NOTICE TO PROSPECTIVE BIDDERS
RI CONTRACT NO. 2025-CB-031
TCB25005700
Corridor - Woonsocket
ADDENDUM NO. 2
September 30, 2025

Prospective bidders and all concerned are hereby notified of the following changes in the Plans, Specifications, Proposal, and Distribution of Quantities for this contract. These changes shall be incorporated in the Plans, Specifications, Proposal, and Distribution of Quantities, and shall become an integral part of the Contract Documents.

STEEL NOTES:

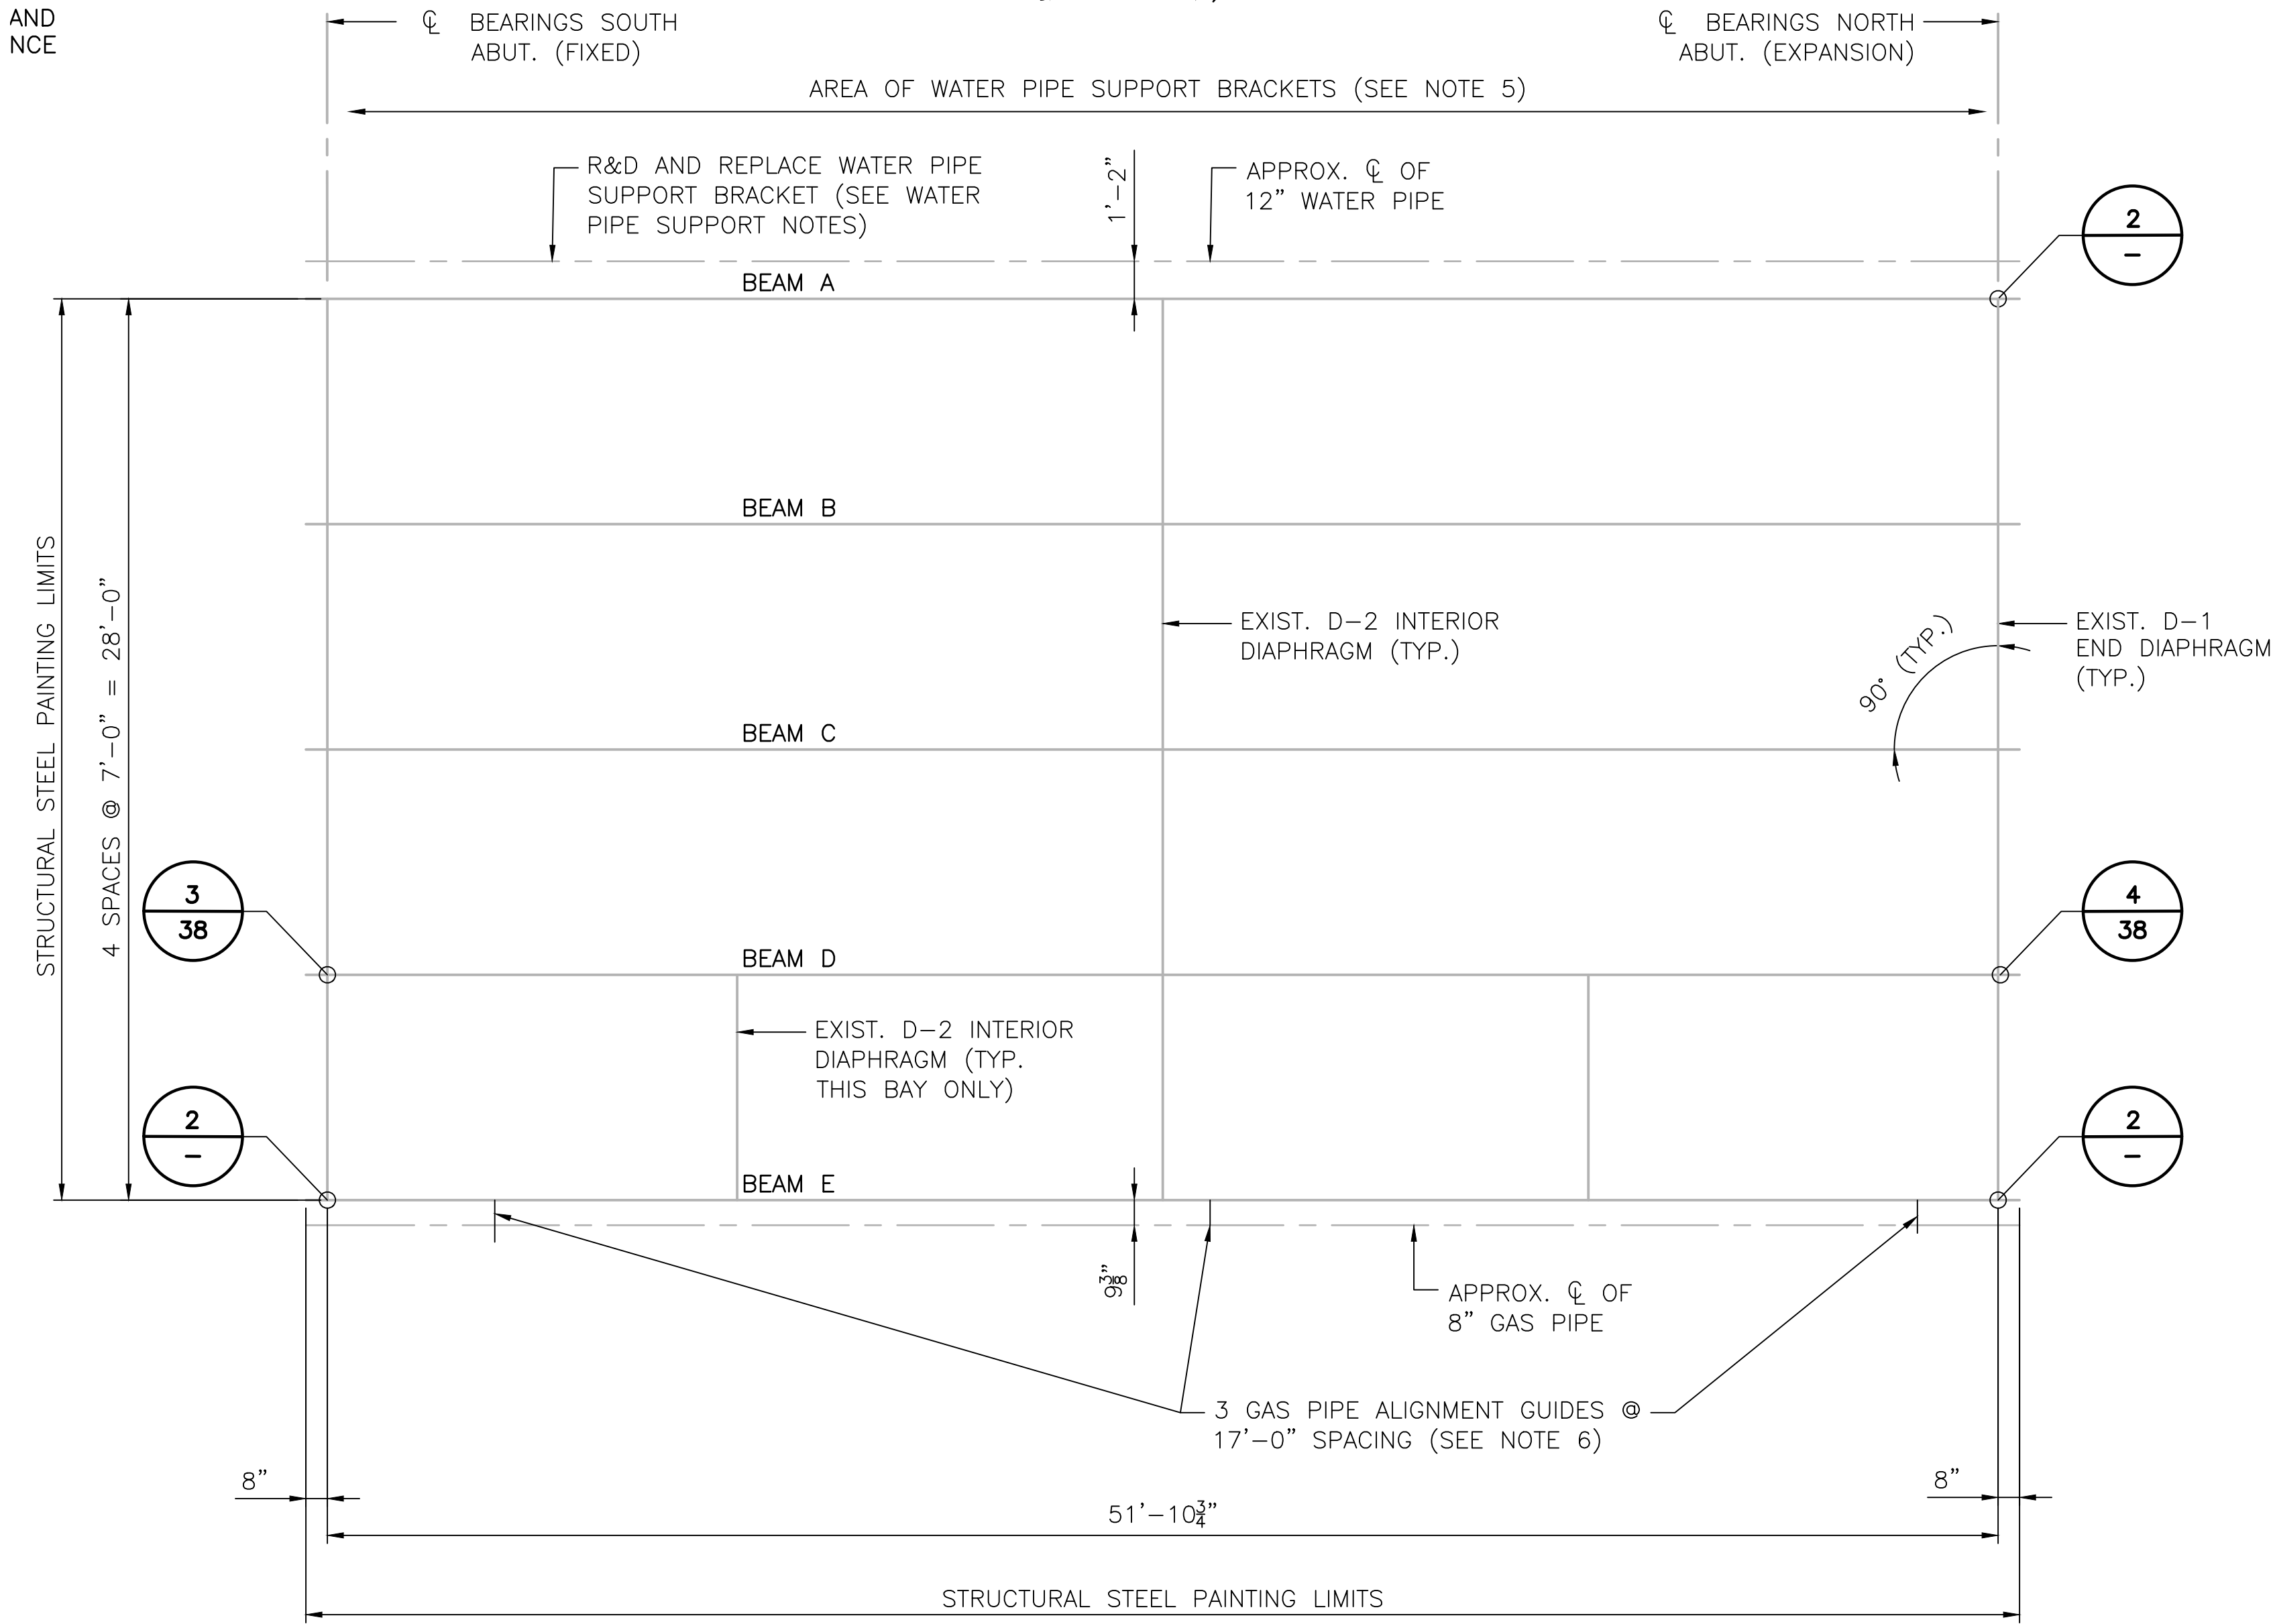
Question Ask By	Question	Answer	Date Submitted	Date Responded
Aetna Bridge Company	Bridge 095301, Sheet 37 has a steel repair detail 1 but the framing plan does not indicate a location for repair detail 1. Please confirm if there is a repair using this detail and the location(s)?	This detail will be removed from the plans by addendum.	Sep 25, 2025 4:27 PM	Sep 29, 2025 3:53 PM
Aetna Bridge Company	At Bridge 068801 the existing dam appears to have extensive deterioration but the drawings do not call for any repair work other than the pressure grouting at the interface with the apron. Please confirm there are is no repair work to be done on the existing dam structure.	No repair work, other than what is shown in the Plans, is proposed for the dam structure.	Sep 25, 2025 4:24 PM	Sep 29, 2025 3:53 PM
Aetna Bridge Company	All the water crossing bridges contain varying quantities of debris that is within the limits of work in the channel. The scopes call for removal and disposal at several of the bridges but does not say how the work is paid except at bridge 068801 which says the work is incidental to Item 201.0321 Clearing and Grubbing. The work to remove the debris from the channel is unrelated to clearing and grubbing which is paid by the SY. Please consider paying for this work on either force account or by creation on a new item.	Removal and disposal of debris within the channel is only proposed at Bridge 068801. This work is considered incidental to Item Code 201.0321.	Sep 25, 2025 4:14 PM	Sep 29, 2025 3:53 PM

- WATER PIPE SUPPORT TO BE REPLACED IN-KIND. SEE EXISTING SUPPORT DETAILS ON PREVIOUS SHEET.
- NEW SUPPORT TO BE INSTALLED DIRECTLY ADJACENT TO THE EXISTING SUPPORT PRIOR TO REMOVAL OF THE EXISTING SUPPORT. LOCATION TO BE APPROVED BY THE ENGINEER.
- PAYMENT FOR THIS WORK SHALL BE INCLUDED UNDER ITEM CODE 824.9901.
